Project Location:	500 Kirkham Street. The property is bounded by 7 th Street, Union Street and 5 th Street and is located east from the West Oakland BART Station.
Assessor's Parcel Numbers:	004 004900800, 004 004900900; 004 004901000 & 004 005101802.
Proposal:	To construct two detached eight and nine-story buildings (Phase 1) and one detached 23-story building (Phase 2) consisting of 1,032 residential units with ground floor retail and flex space commercial areas, parking garage, courtyards, roof deck, terraces, pedestrian commercial pathways.
Project Applicant/ Telephone:	Zac Shore, Panoramic Interests / (415) 701-7002
Property Owner:	500 Kirkham, LLC
Case File Number:	PLN17428/ PUDF07
Planning Permits Required:	Planned Unit Development / Conditional Use Permit; Regular Design Review; Minor Variances; and Tentative Parcel Map Subdivision.
General Plan; Specific Plan:	Community Commercial; West Oakland Specific Plan (WOSP)

Case File: PLN17428 - PUDF07
Applicant: Panoramic Interests, Zac Shore
Address: 500 Kirkham Street (bounded by
7th St, Union St, and 5th St)
Zone: S-15W
Height Area: 160 ft

Design Review Committee

Case File Number: PLN17428 / PUDF07

OVERALL GROUND FLOOR PLAN

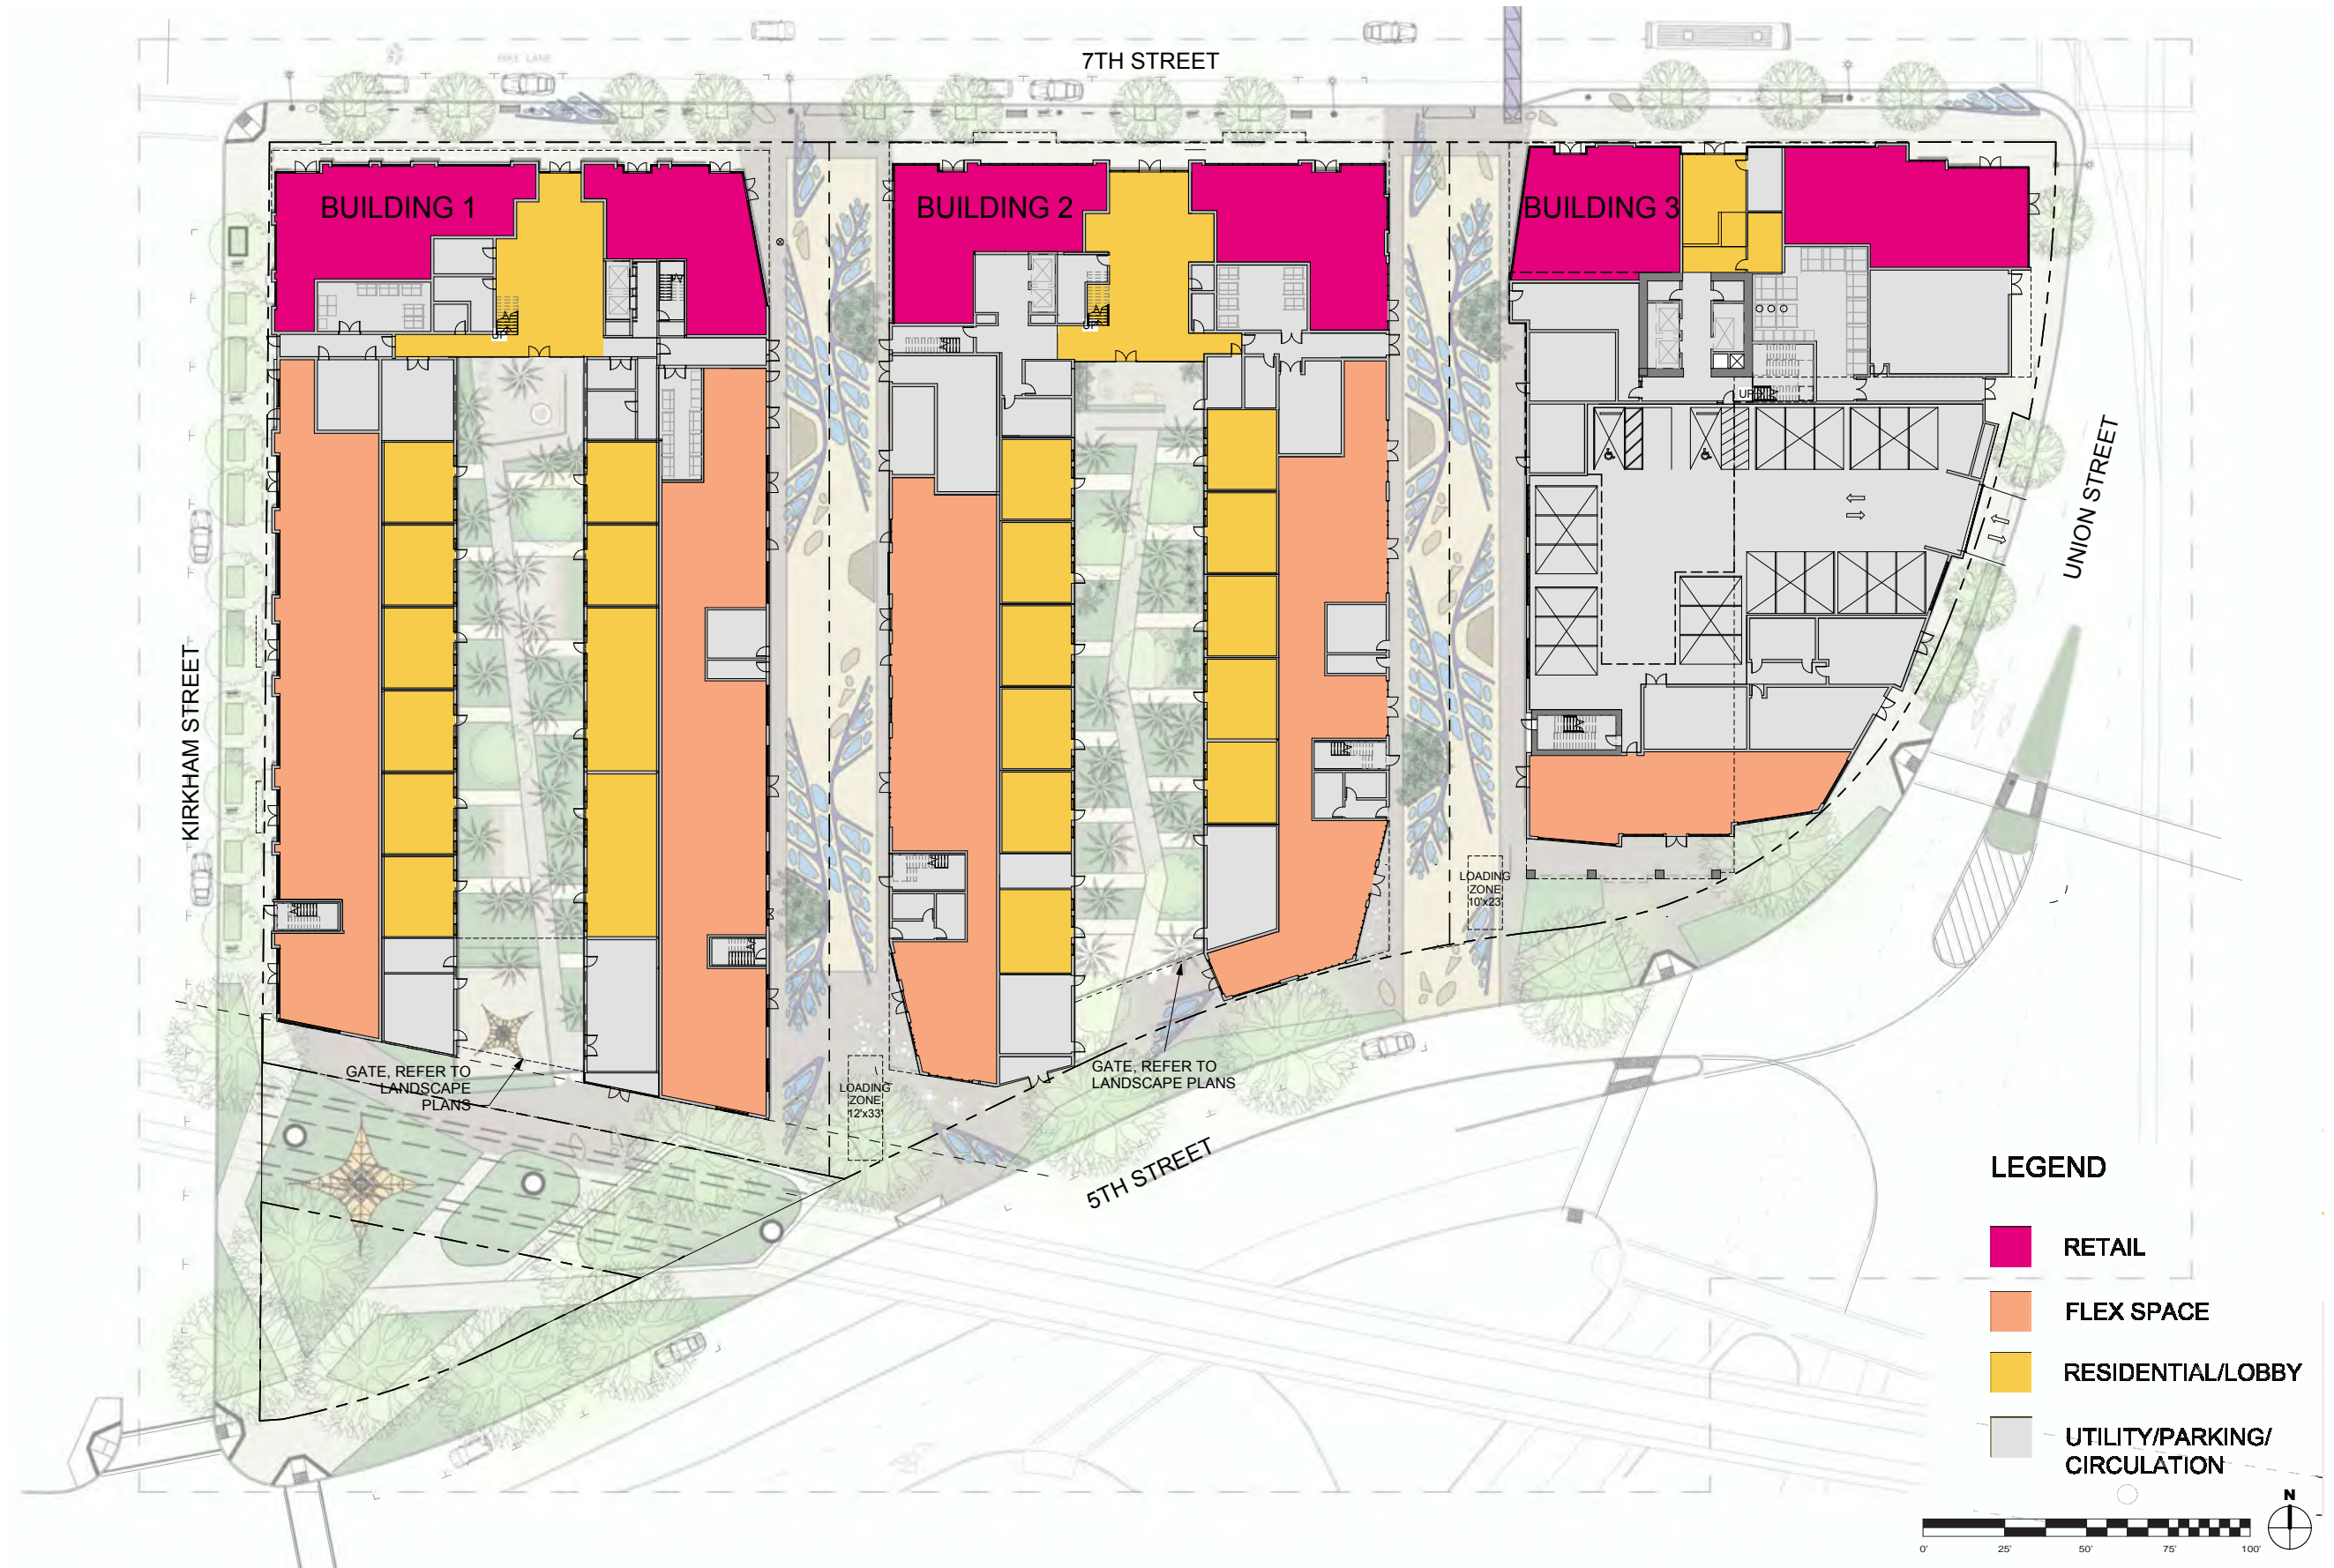
3. Show service circulation for the flex spaces	Buildings 1 and 2 provide additional trash rooms on the ground floor and to the rear of the retail spaces. The plans, however, do not show service circulation to prevent conflict with the proposed public open spaces and sidewalks.

There are no significant changes to the envelope of the buildings, however, the modified site plan shows improvements along 7th Street and 5th Street. The ground floor of Buildings 1 and 2 have been pulled back approximately seven feet from the front property line on 7th Street to create a much wider sidewalk of 17 feet. The size of the new sidewalk would encourage more pedestrian activity and interaction with the storefront businesses, and allow the installation of street furniture such as benches. Buildings 1 and 3 also show the ground floor side walls have been pulled back approximately five feet to widen and make the entry of the alleyways more visible and welcoming from 7th Street. Furthermore, Building 3 shows the ground floor has been pulled back approximately 12 feet from the rear property line on 5th Street to provide a much wider pathway and encourage walkability. Building 2 also has two of the ground floor side walls pulled back to provide better circulation of the entry public alleyways from 5th Street. The widening of the pedestrian pathway along the rear of the property would make 5th Street more attractive and help guide the public to the alleyways and around the property.

OVERALL ROOF PLAN

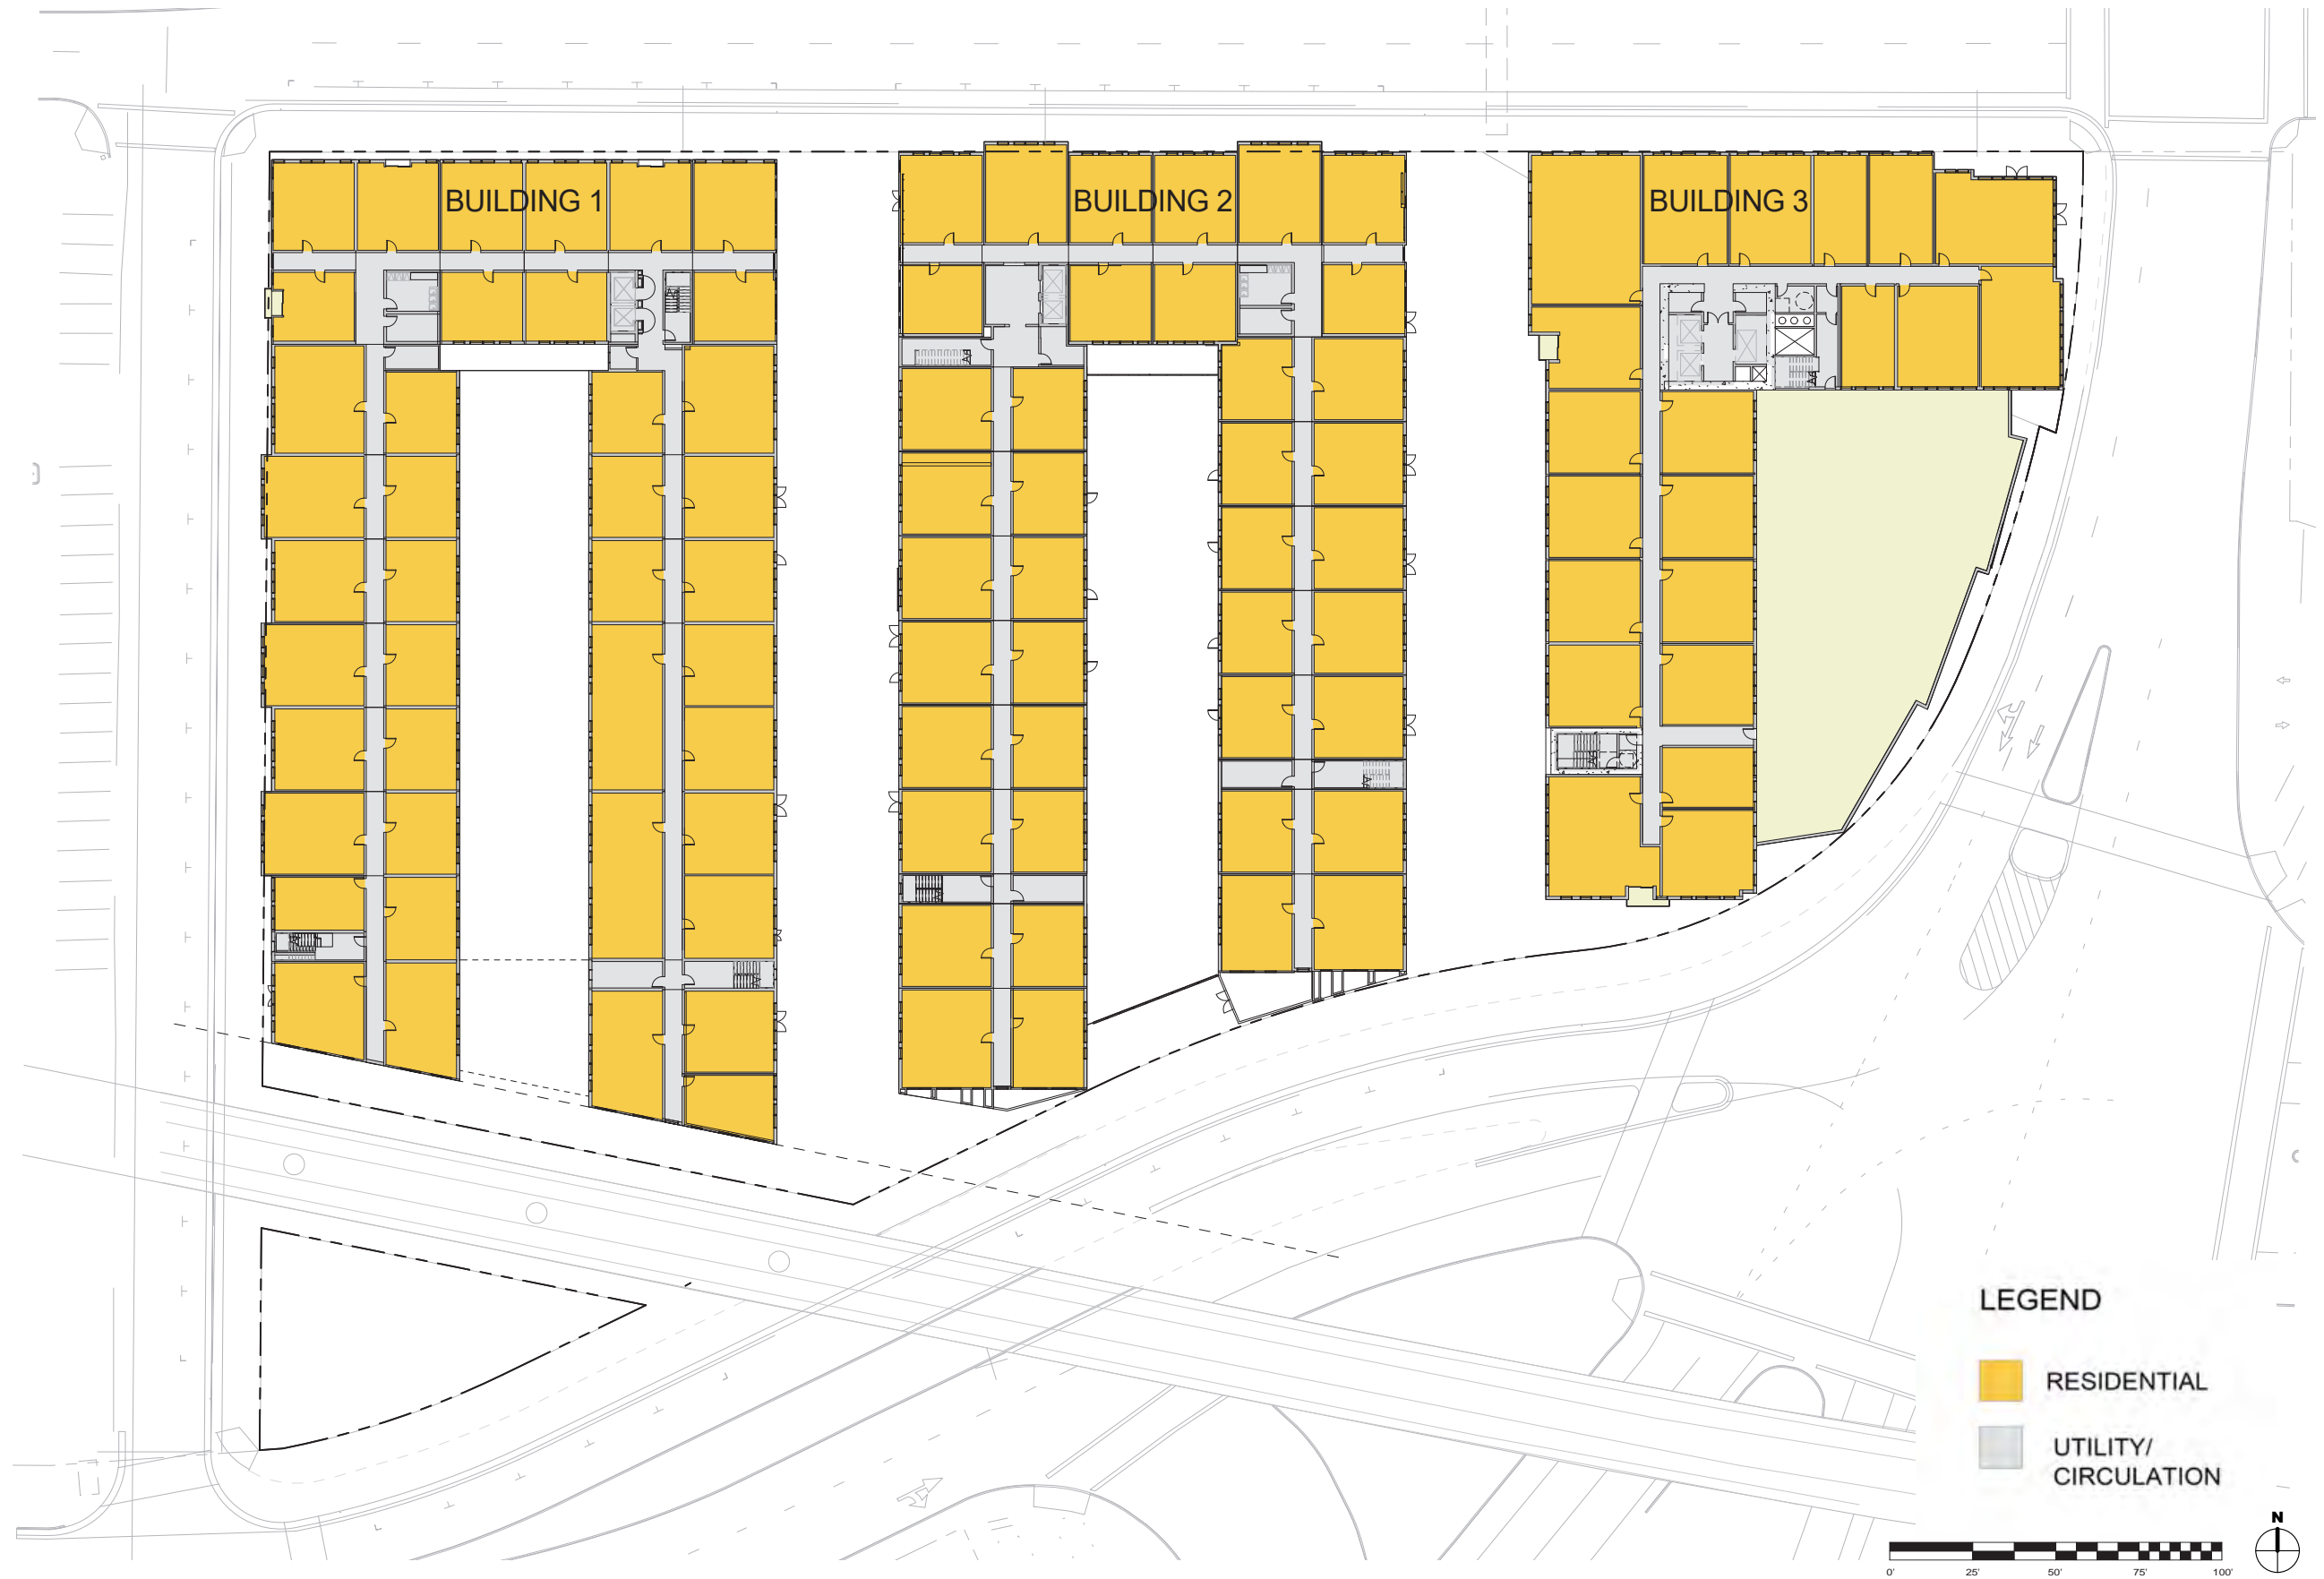
2. Provide roof plane variation	Buildings 1 & 2 (mid-rise) do not show any changes to break up the roof planes. Building 1 shows no changes and continues to have a single plane; and Building 2 proposes a screen around the parapet that lacks articulation and visual interest to reduce mass.

Many modifications have been made to improve the building design of this large and complex project. The building design contains design elements that help to break up mass and bulk of the facades, except for the roof planes of the mid-rises. Staff believes that some modifications are needed to reduce the roof planes of the mid-rises. The proposed screen wall over and around the building parapet does not help to break up the long horizontal plane, but instead it exacerbates the mass without providing any visual relief

of the building when viewed from public view. Staff recommends that a robust and interesting design feature such as a non-linear decorative blade is installed along the roof parapet. Staff also believes that all windows should be recessed from the building façades to provide depth and articulation. Staff recommends that the plans show detail window recesses, and that the applicant include specifications on the plans.

GROUND FLOOR

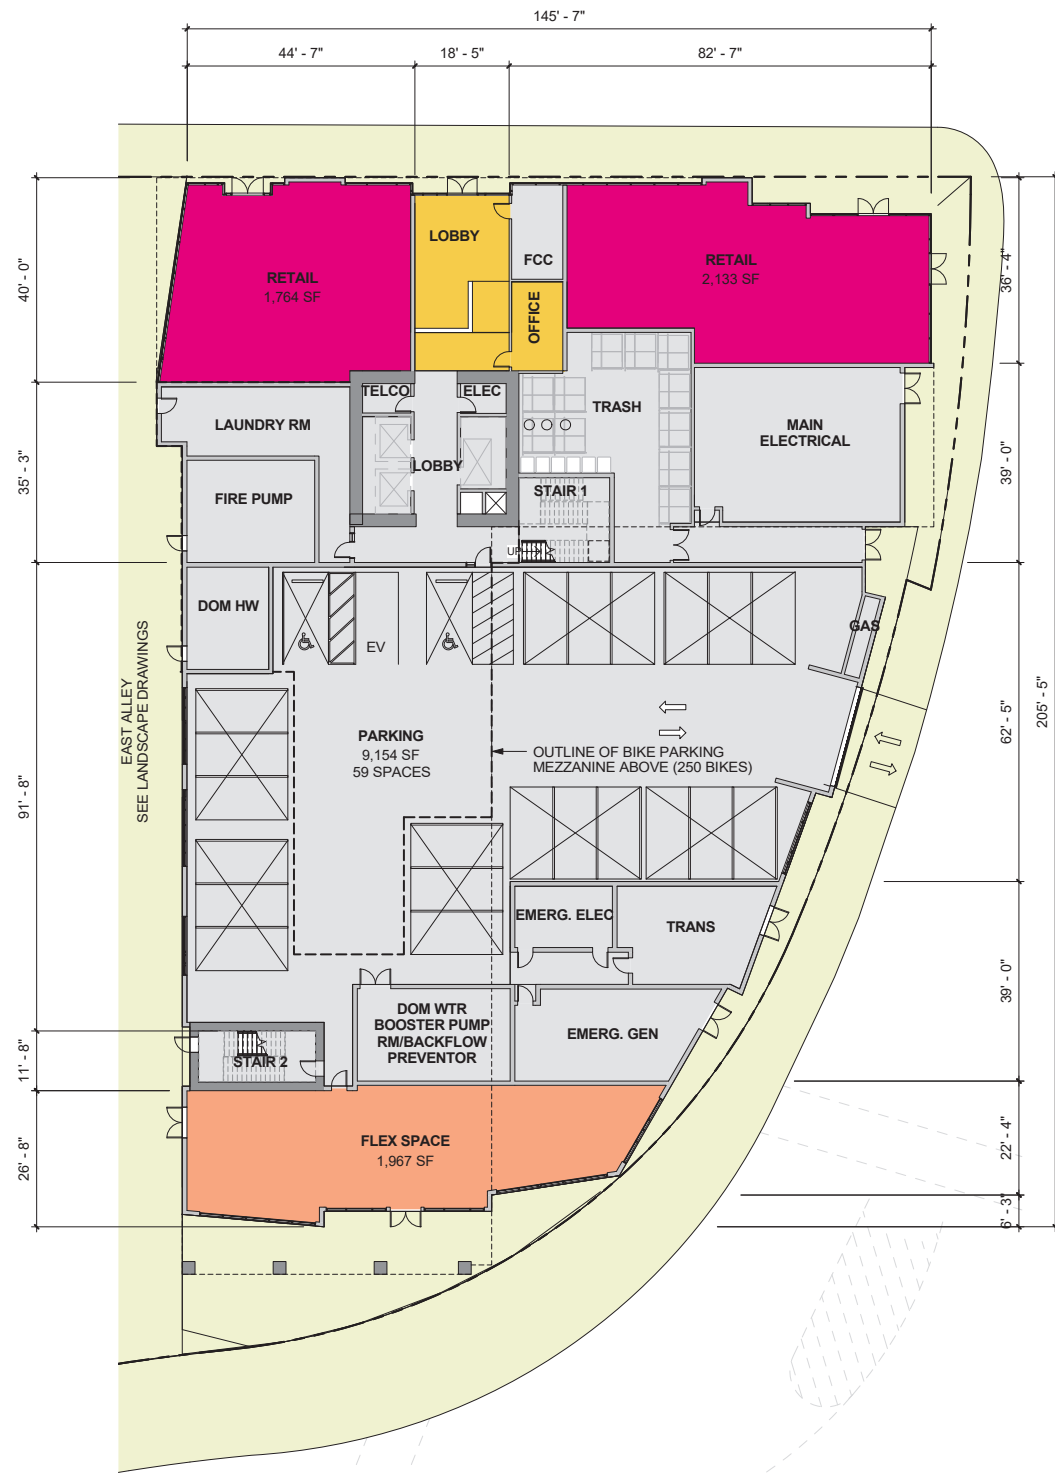
A parking garage with 59 spaces will be located on the ground floor of the high-rise building. Based on revised plans submitted it appears that the parking spaces would be placed on stackers. Access to the parking garage will be from Union Street. Because the sidewalk is narrow, and there is no on-street parking on Union Street, it is recommended that the garage door is placed away from the sidewalk, so vehicles driving into the garage do not block pedestrians or traffic flow. Staff also recommends that the parking stalls be independently accessible from the stackers. Given that the parking garage will be part of the project entitlements for Phase 2, staff suggests that the final subdivision maps include the layout and parking space count for the garage in the recordation of the final map. The project also includes commercial and residential loading spaces within Building 2 (Phase 1) and Building 3 (Phase 2). These two loading spaces are uncovered and located on the proposed public alleyways, and will be accessed from 5th Street. It is unclear how the two loading spaces will be accessed from the street because the plans do not show any proposed curbcuts along 5th Street. These two loading spaces will also conflict with the proposed public alleyways, and may become a nuisance to future residents because the residential buildings would be within proximity. The applicant may consider applying for a variance with Planning, and ask if the City's Public Works Division would consider a permit for constructing a pull-in commercial and residential loading curb along 5th Street.
